# CHAPTER 4.0

## ERRATA

This Errata has been prepared in response to additional information that became available subsequent to publication of the Draft EIR for the Wistaria Ranch Solar Energy Center (Original Project) which was circulated for a 50-day public review period in compliance with Public Resources Code 21091 from August 22, 2014 thru October 10, 2014. Following the close of the public review period for the Draft EIR, the Applicant submitted a letter dated October 30, 2014 to the County of Imperial Planning and Development Services Department (ICPDSD) Director, Mr. Jim Minnick and the Project Planner, Mr. David Black, recommending that the County approve and certify the Reduced Size Solar Generation Facility Alternative (i.e. Alternative 2) in order to further reduce impacts associated with CUP 13-0047 (Letter from Robert A. Ramaekers, Vice President, Wistaria Ranch Solar, LLC, dated October 30, 2014). On November 19, 2014, the Applicant submitted a follow-up letter to the ICPDSD requesting revision of the Project application so that the Reduced Size Solar Generation Facility Alternative is selected resulting in withdrawal of CUP 13-0047, a 130-acre site (see **Figure 6

**FIGURE 3.0-1  
CUMULATIVE PROJECTS MAP**

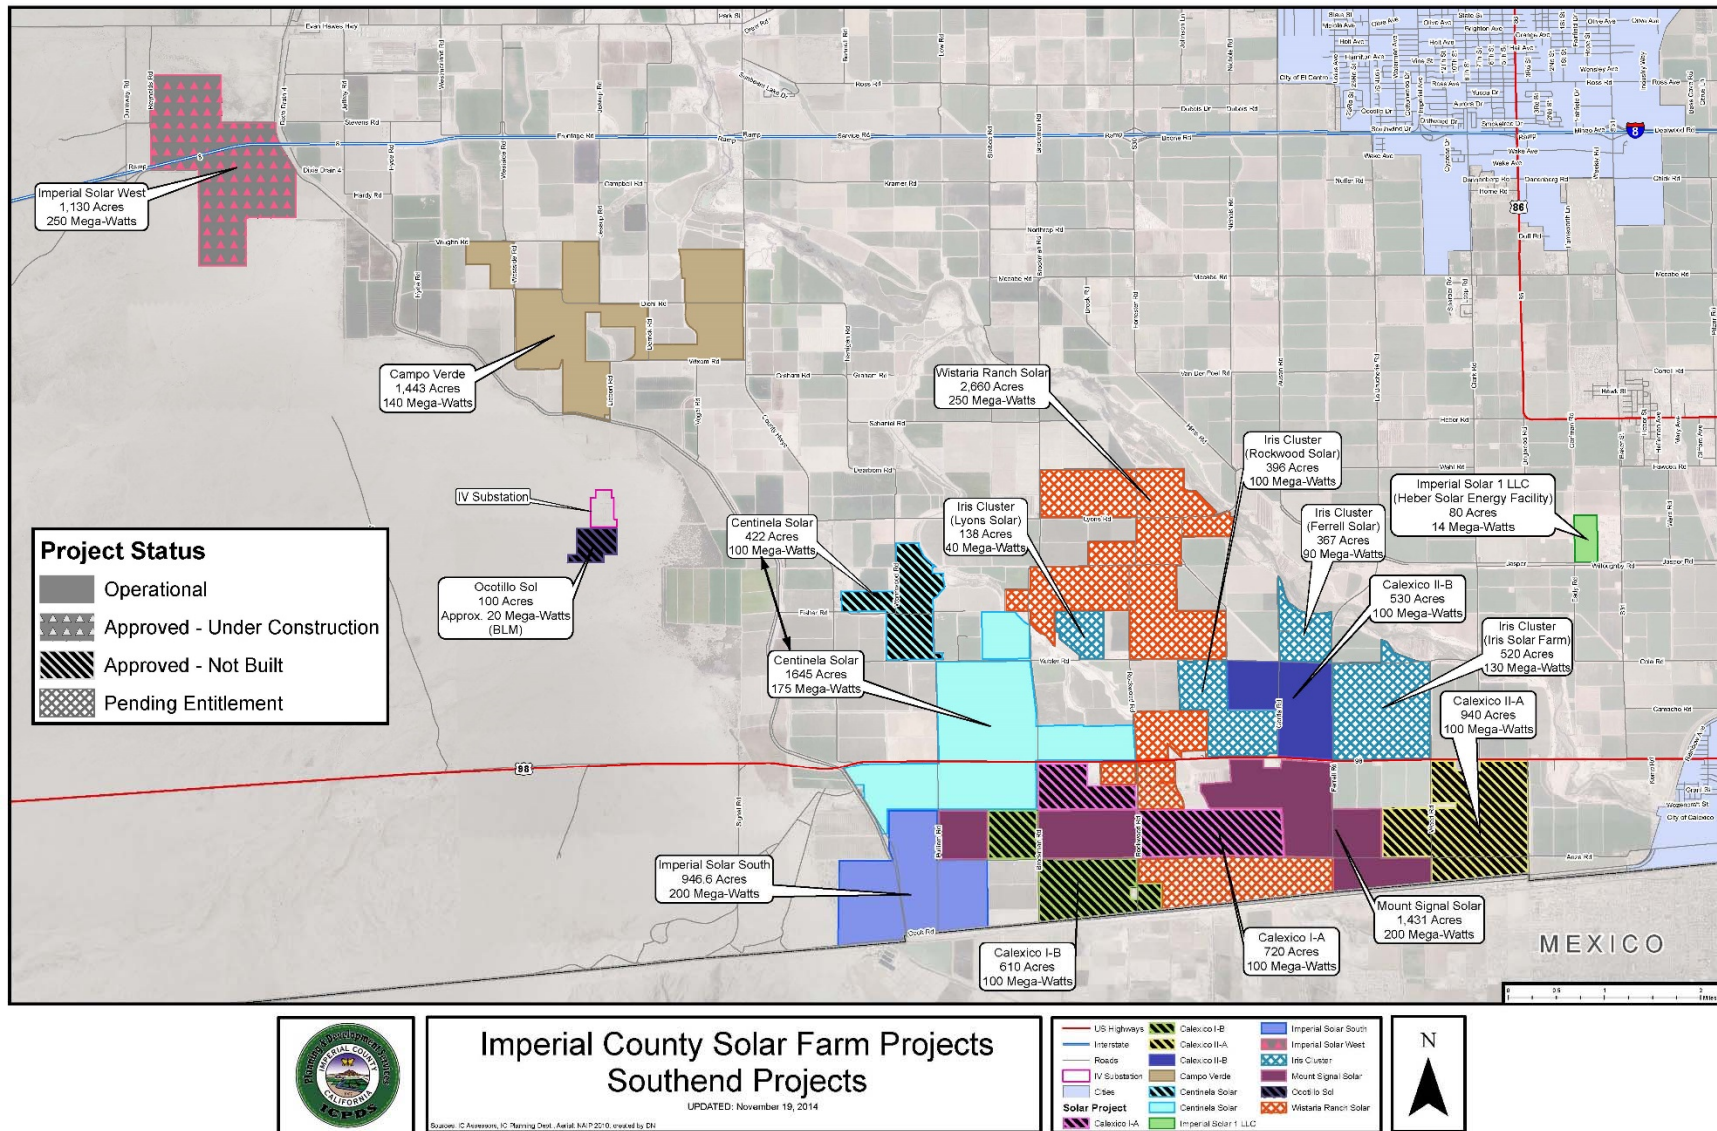
Figure 3.0-1, Cumulative Projects Map has been revised to reflect the Preferred Alternative.
